ADDENDUM NO. 1

**HANOVER COMMUNITY SCHOOL CORPORATION - NEW RESOURCE
CENTER AND RELATED WORK
Cedar Lake, IN 46303**

This Addendum consists of page ADD 1-1 and attached Addendum No. 1 from Gibraltar Design dated May 27, 2021 and consisting of 5 pages and 48 drawings.

DRAWING
**WALL SECTIONS
RESOURCE CENTER
BUILDING D**

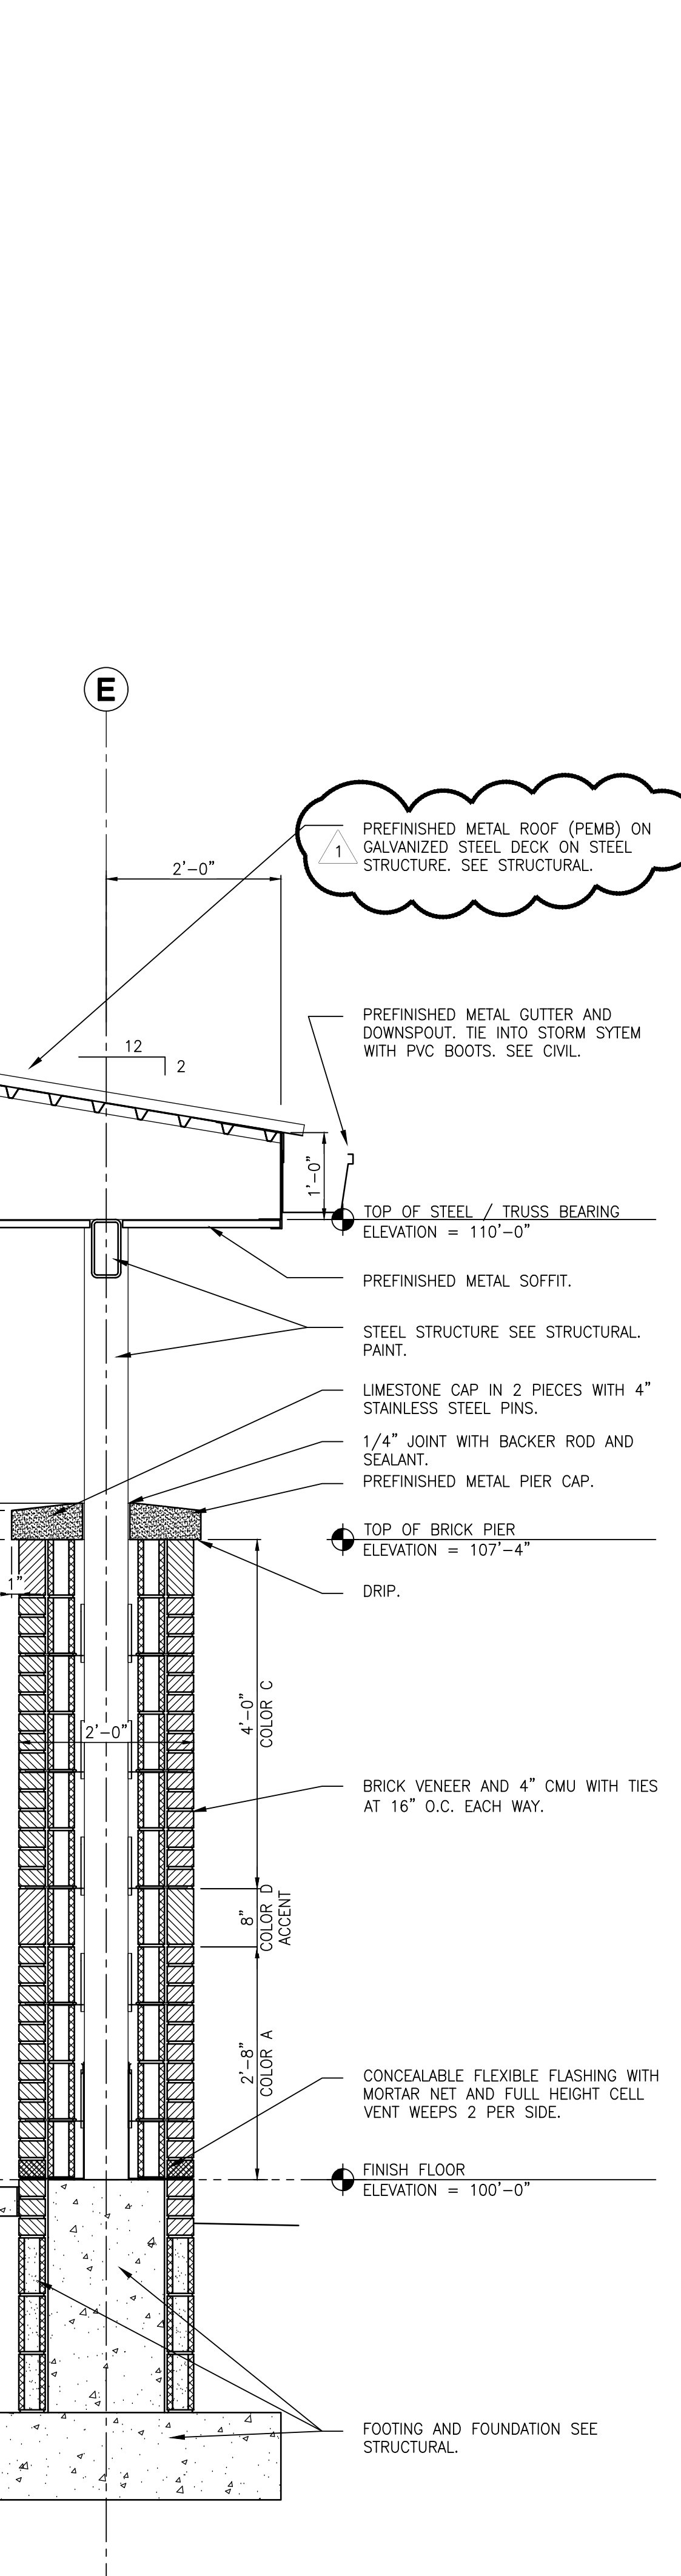
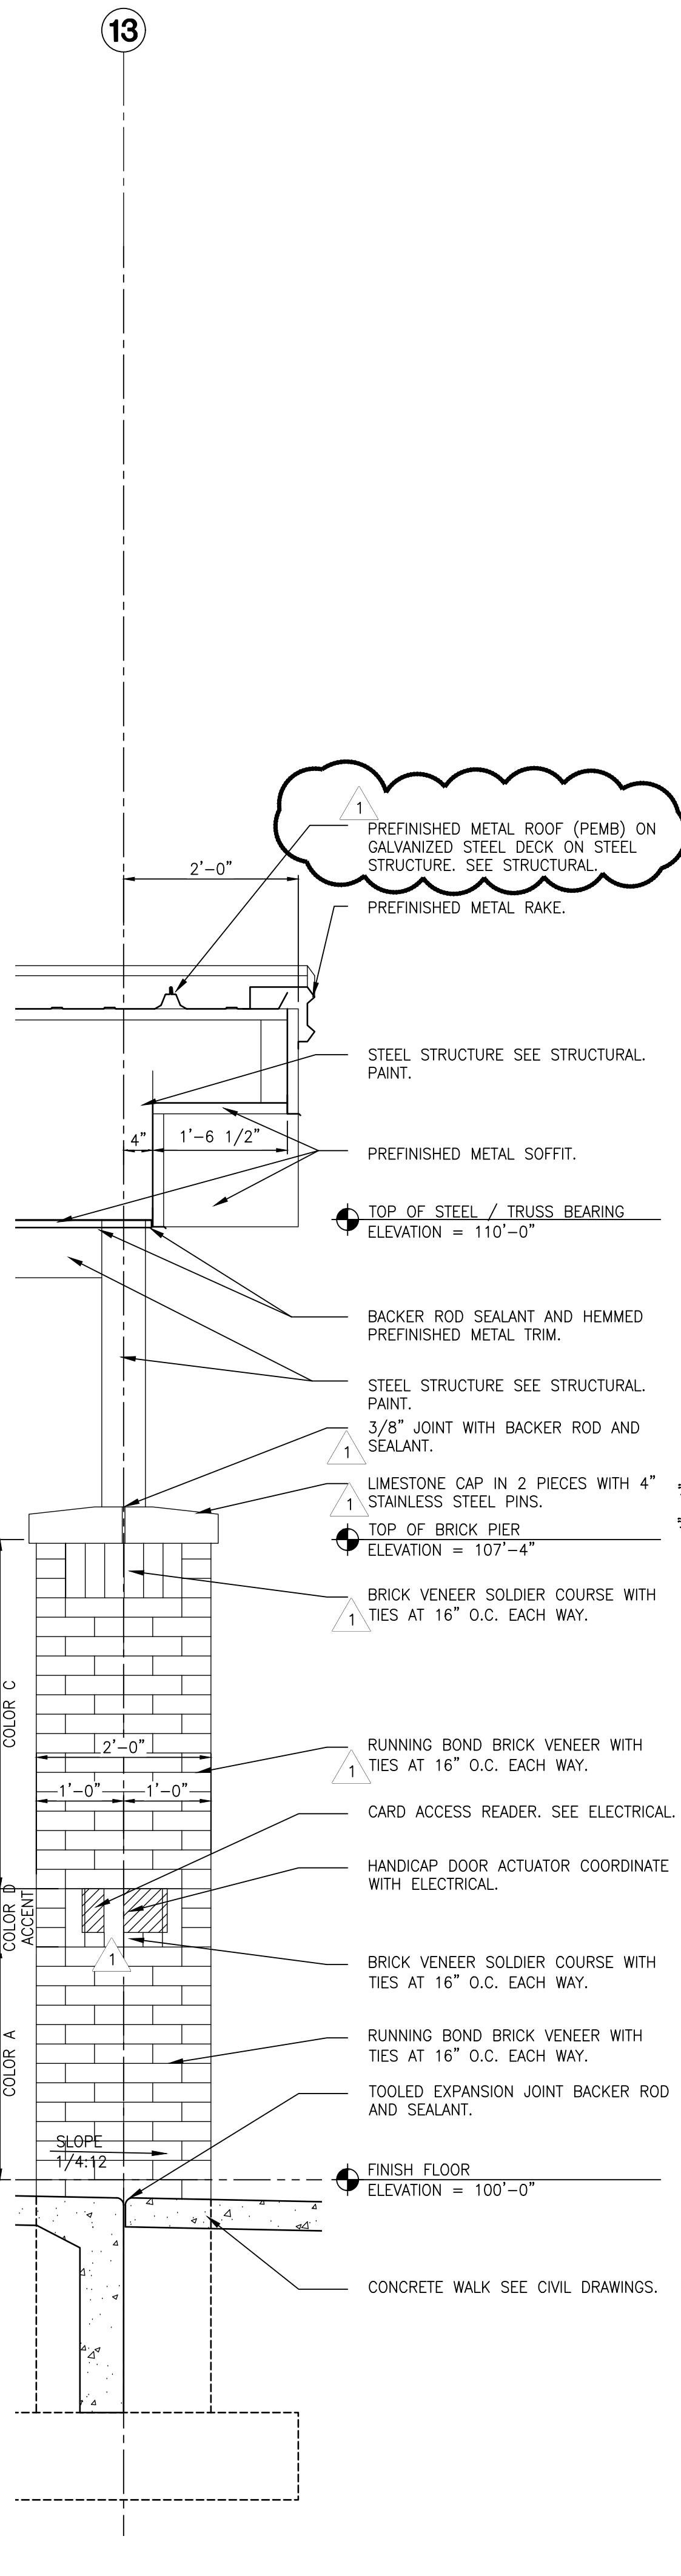
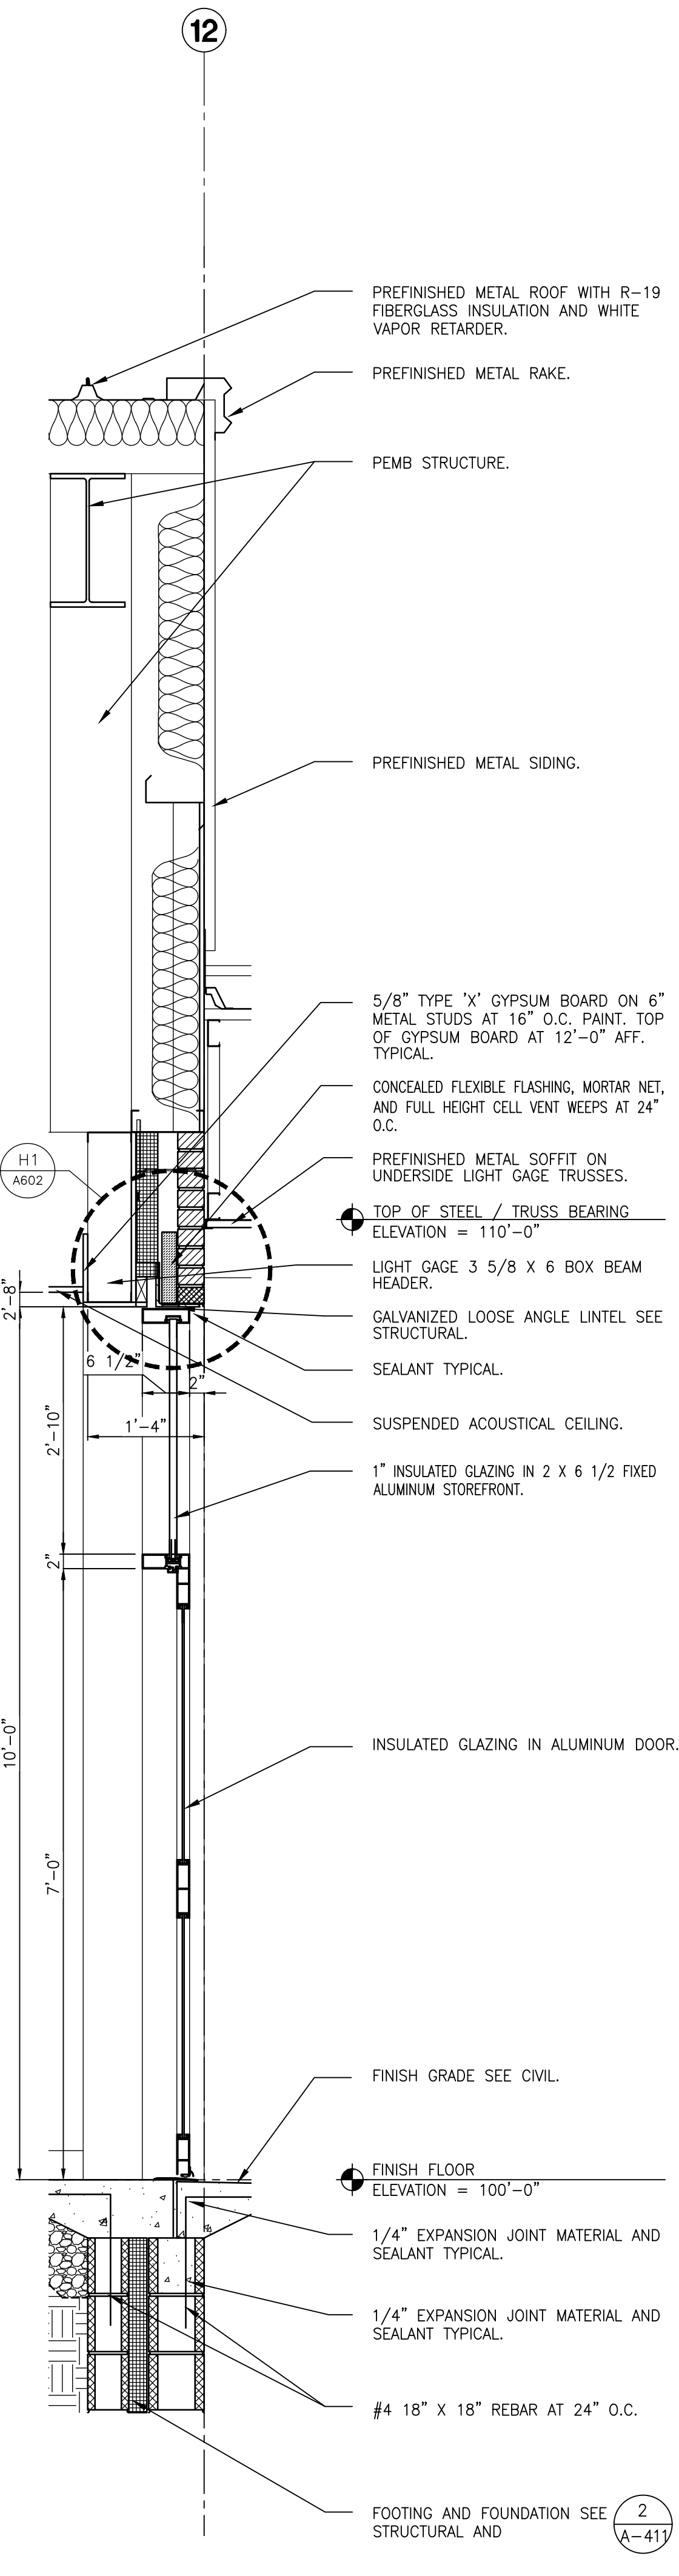
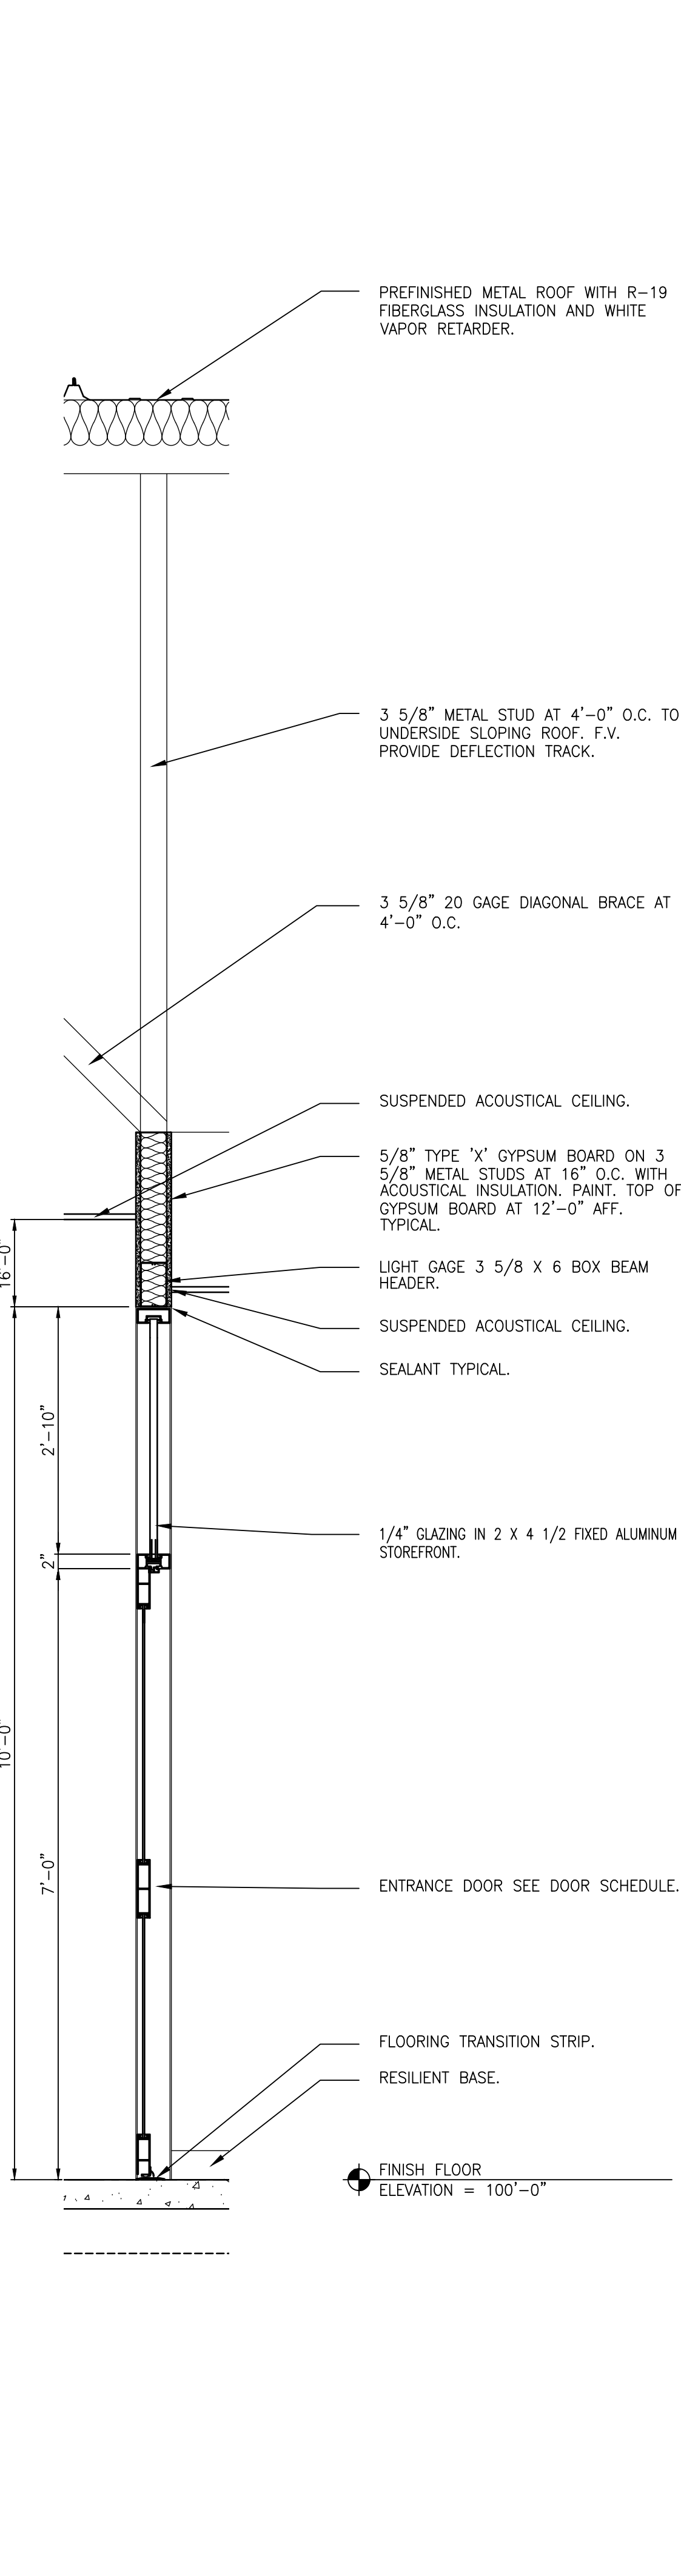
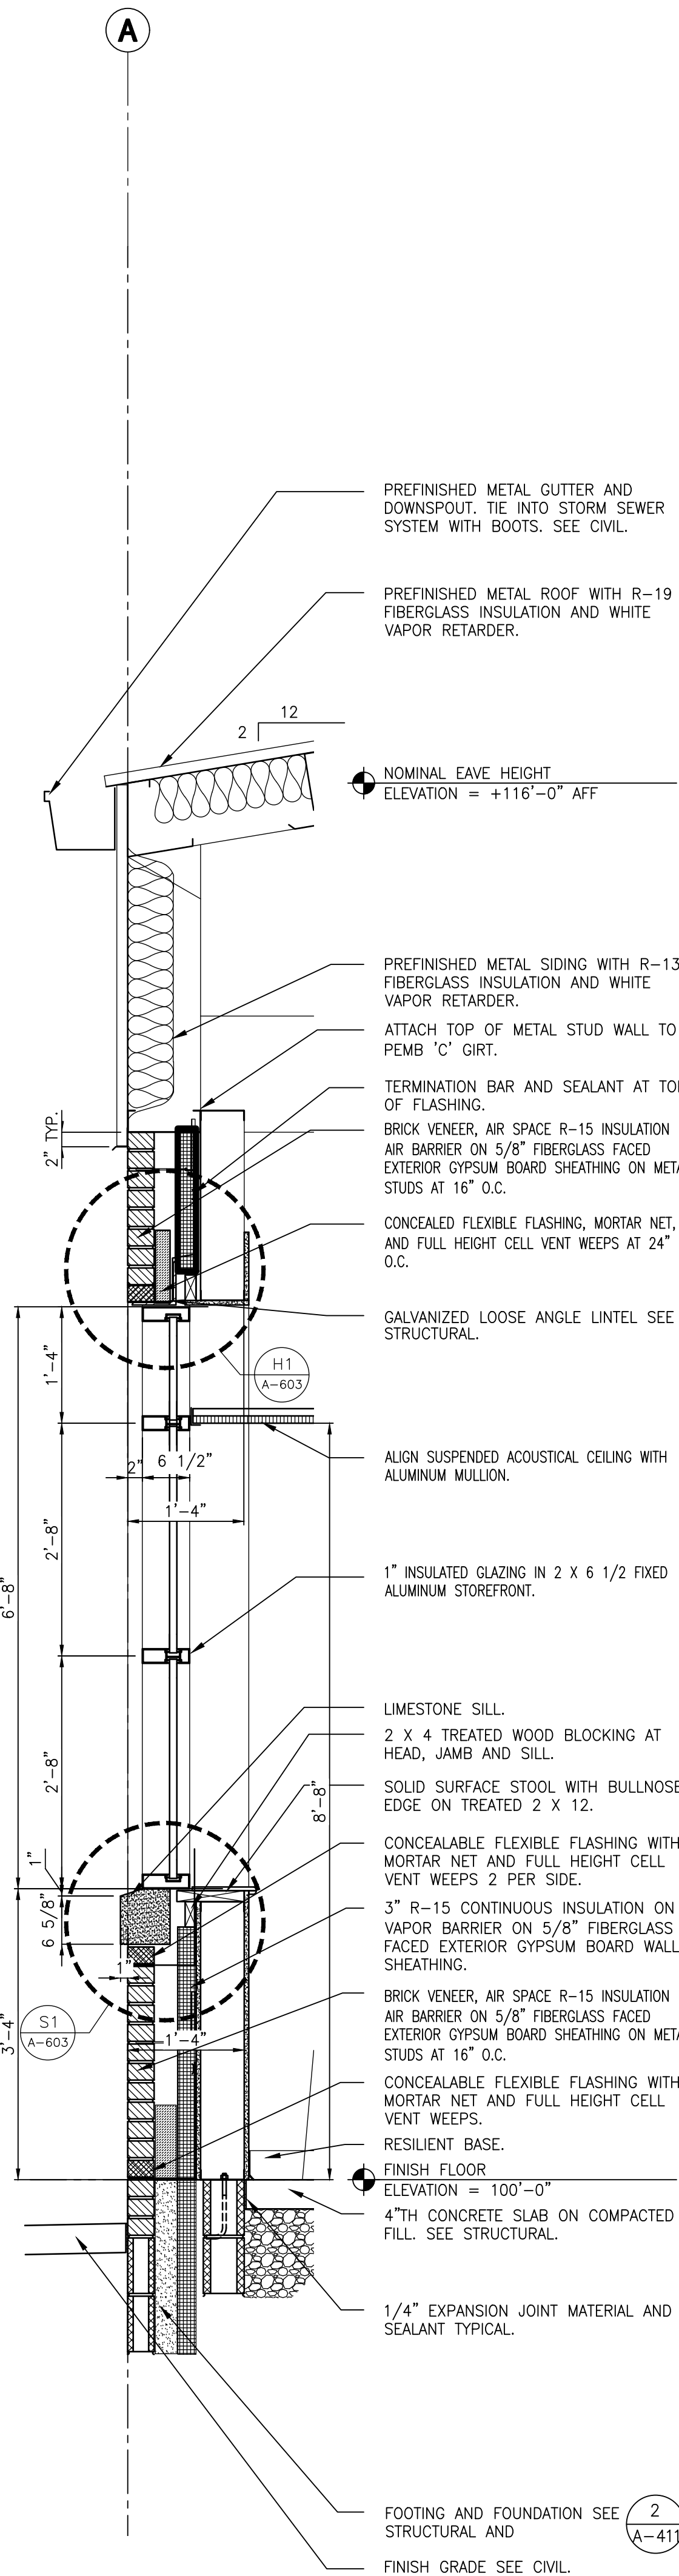
16. Sheet A-409 and A-410

- A. Refer to two (2) Full Size Drawing Sheets included in this Addendum for revisions.
